Approved Rear Elevation

As Proposed Rear Elevation

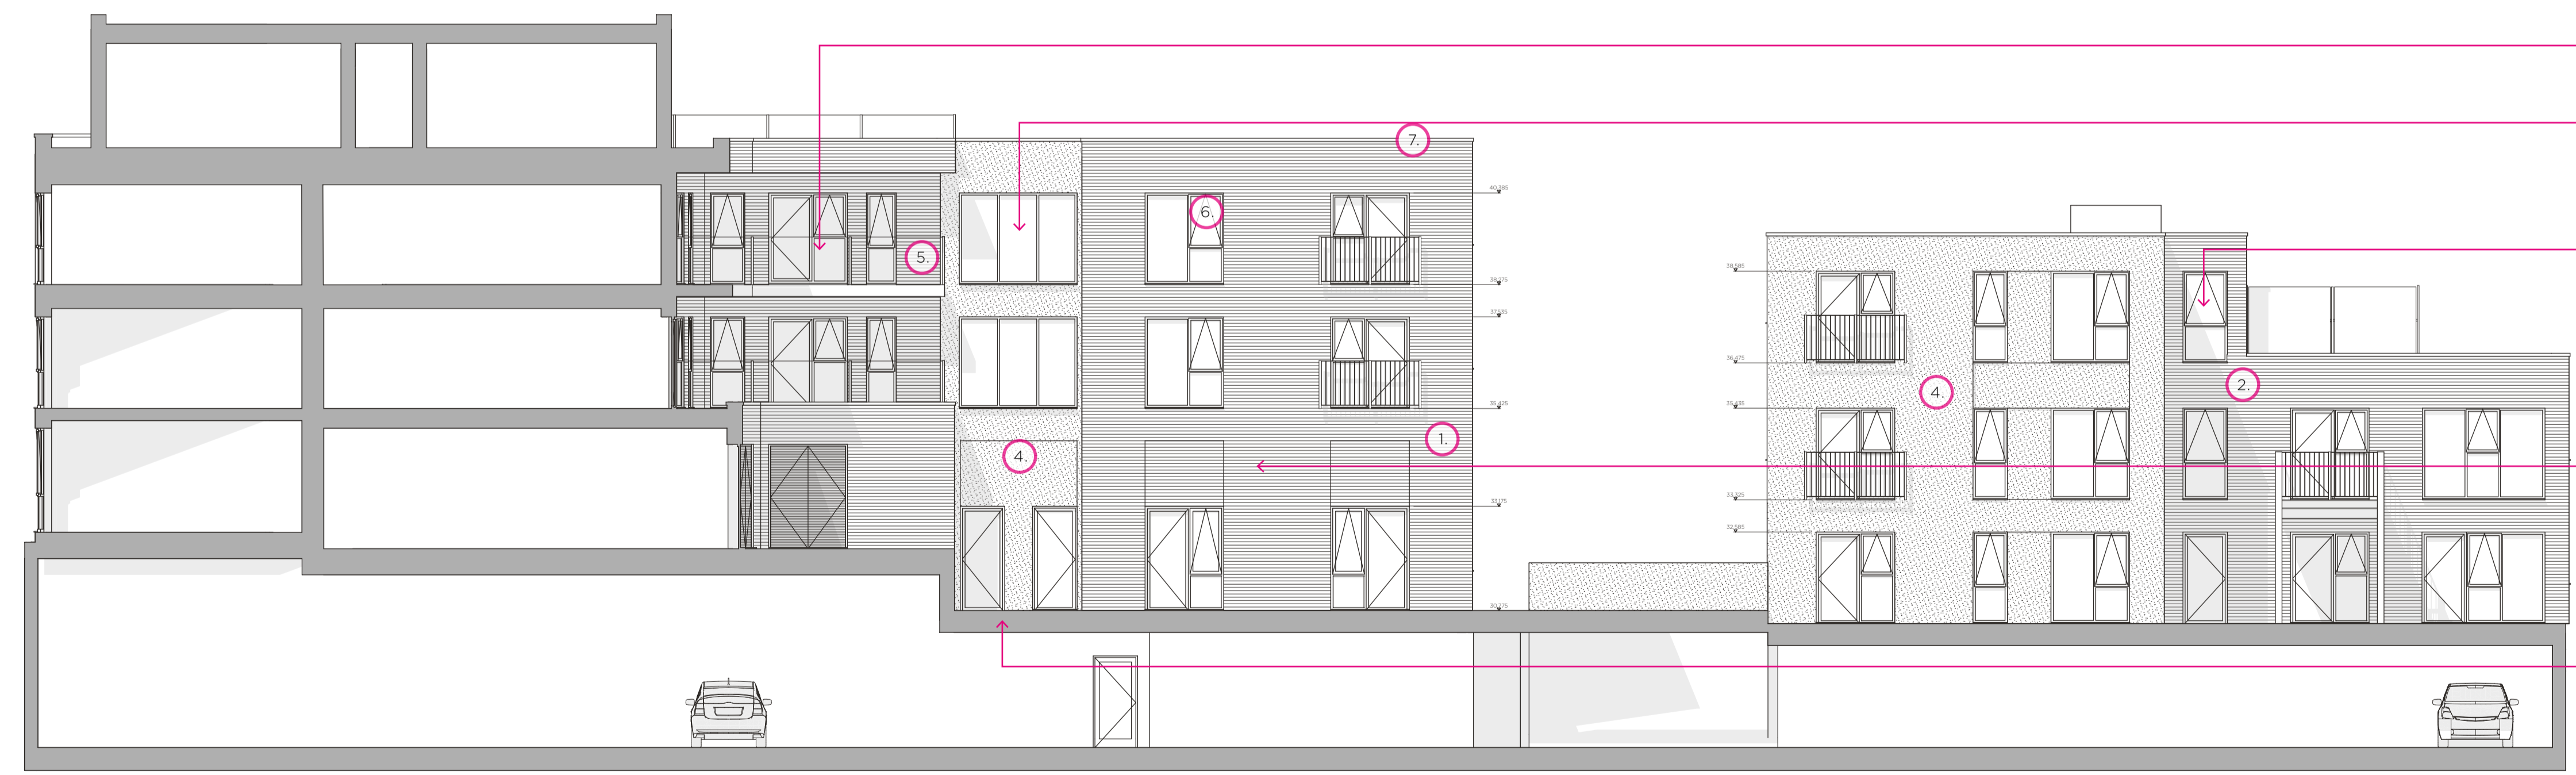
- Proposed inset balcony to replace juliet balcony and window layout.
- Removal of balconies to suit layout alteration for new staircase location.
- Removal of inset and façade to become flush with the rest of the elevation.
- Ground floor ceiling height extended to correspond with the step up and site level alteration.
- Levels altered and stepped up to coincide with the existing site levels.
